FINAL ISTT DESIGN

ADDENDUM

IN-SITU THERMAL TREATMENT
FRONTIER FERTILIZER NPL SITE
Davis, CA
Submittal #0012
Final RAMP
Specification 01400, Paragraph 1.5

FINAL DESIGN REPORT
ADDENDUM
IN-SITU THERMAL TREATMENT
FRONTIER FERTILIZER NPL SITE
Davis, CA

Figure# 11B

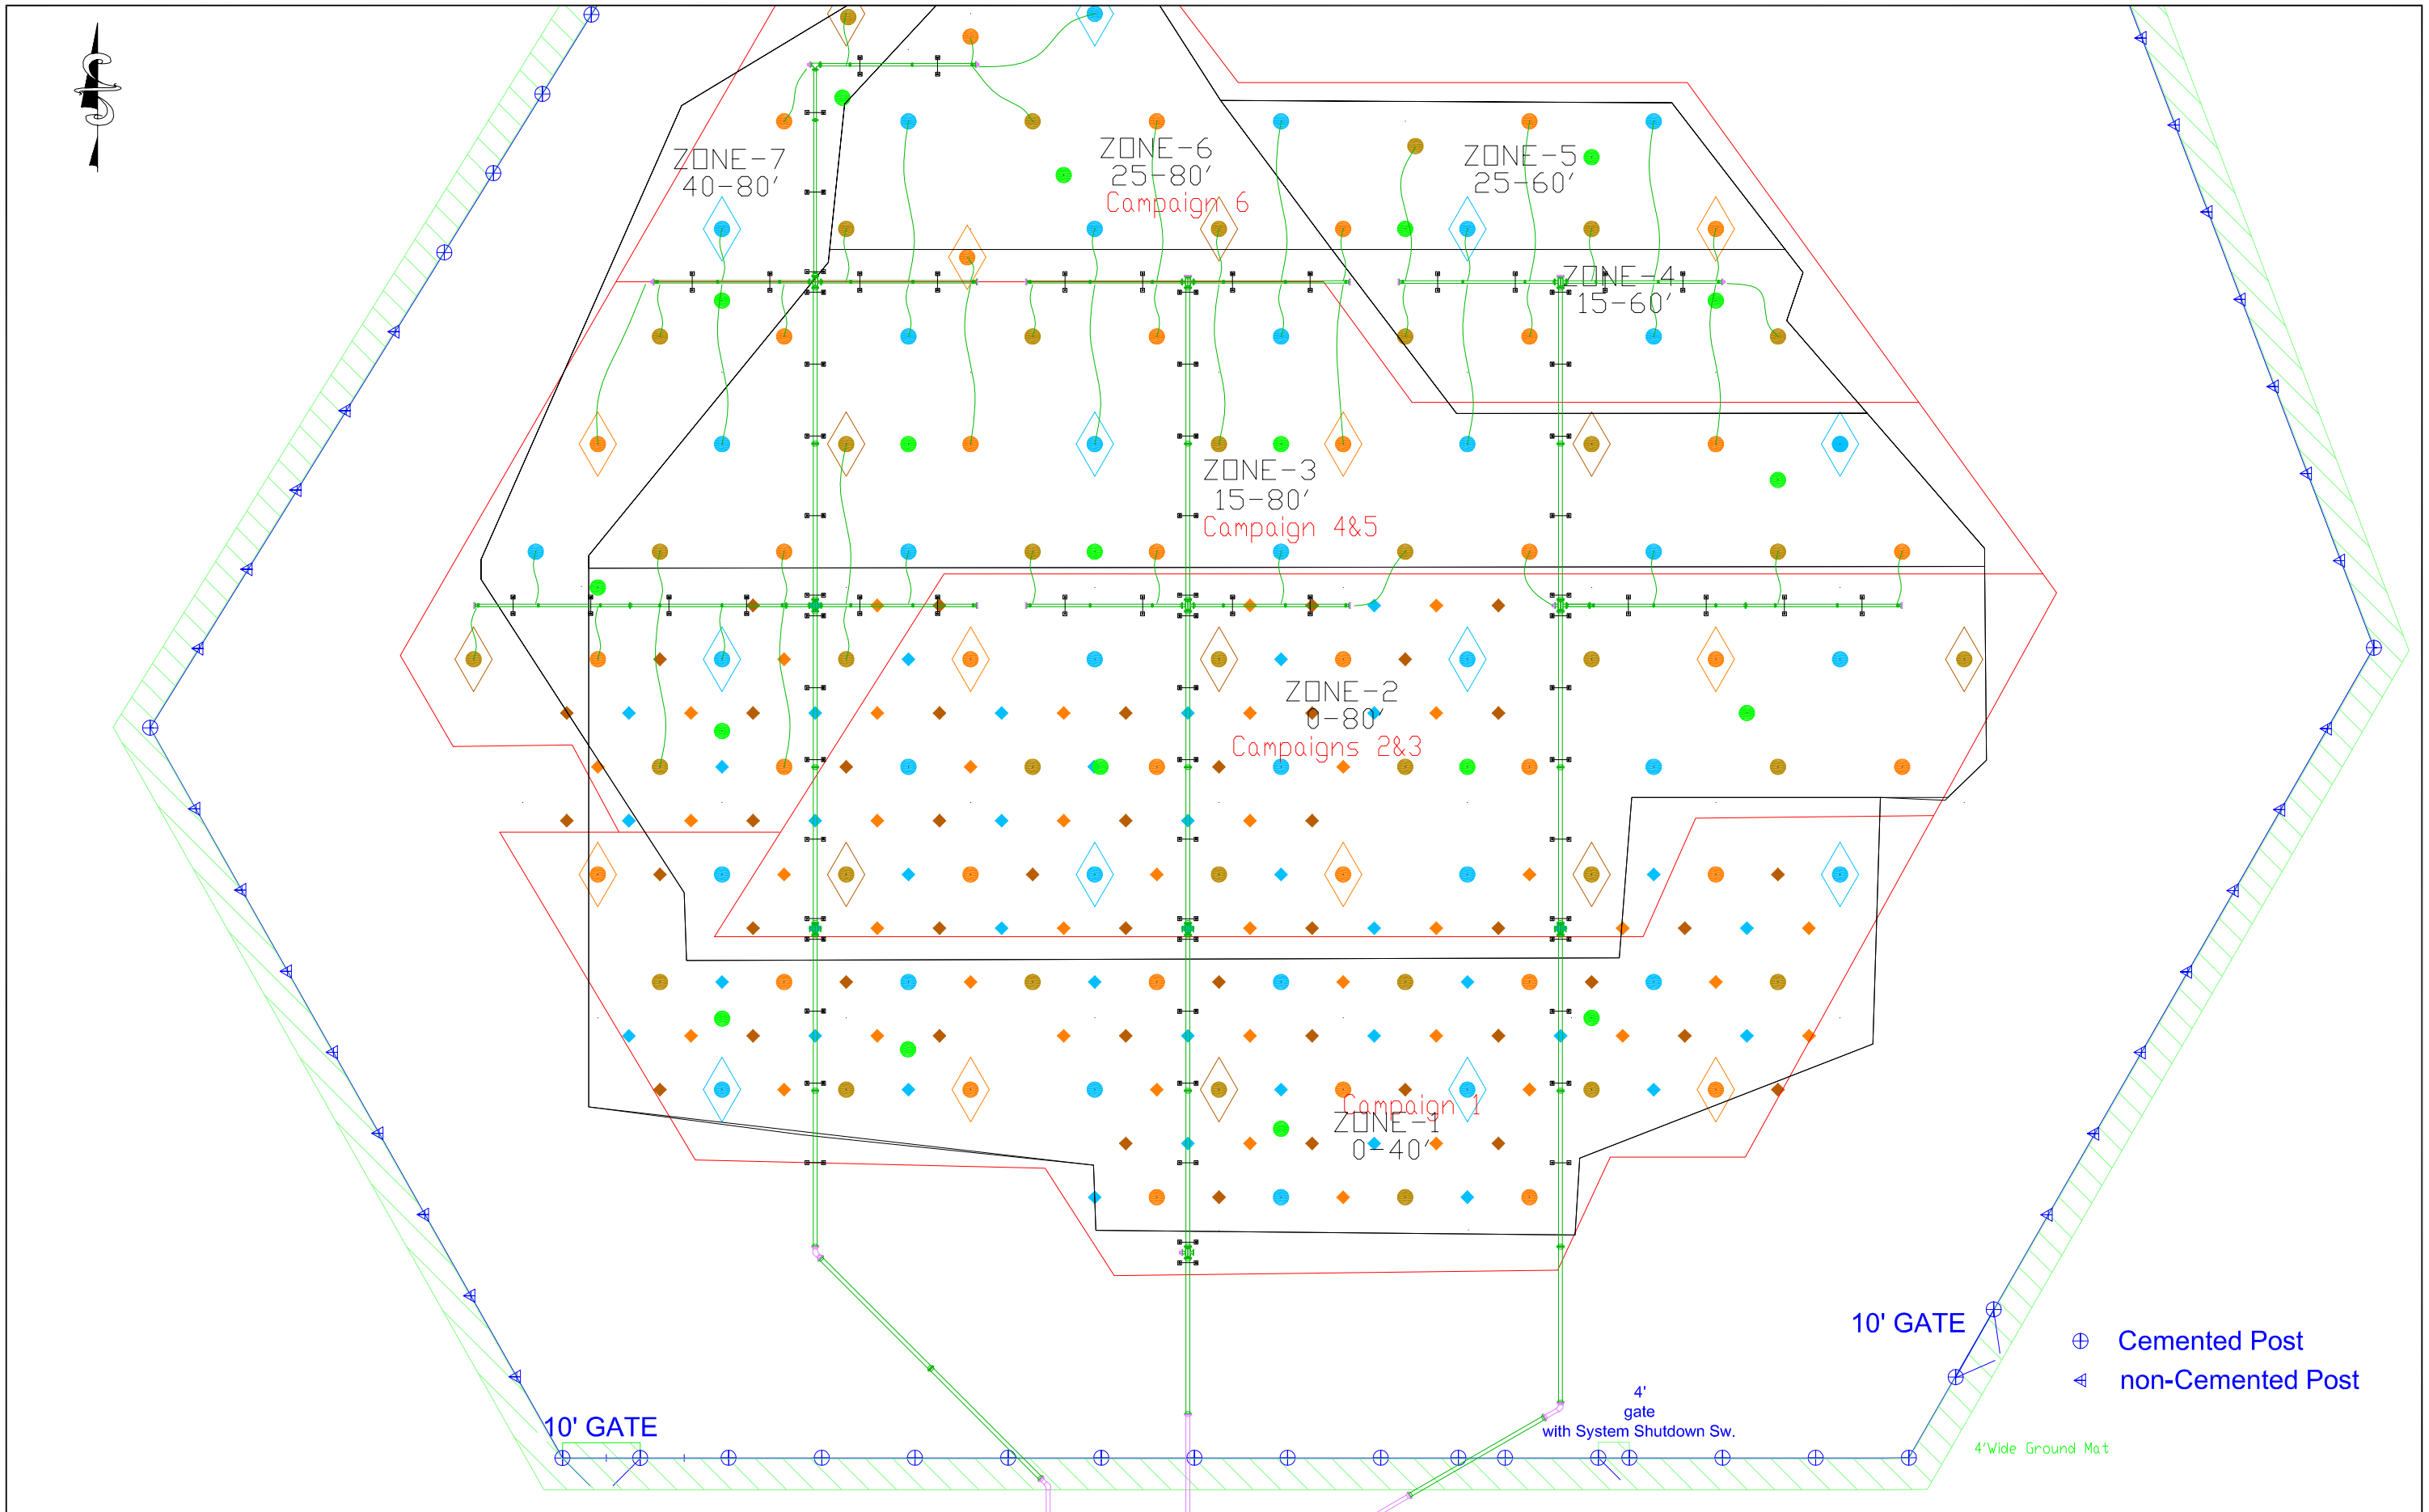
The manifolds are sized to handle the maximum expected flow per well, with about 50% additional capacity built into the piping system, at a target velocity of about 30 ft/second. Figures 11A, B and C show the layout of the piping manifold from each electrode to the process equipment area for Stages 1, 2 and 3, respectively. As more electrode wells are connected to the manifold, the size of the manifold increases to handle the additional combined flow. The manifold is designed to handle flow of vapors, water and steam simultaneously, with flexible wellhead connections, short runs and open supports to accommodate thermal expansion.
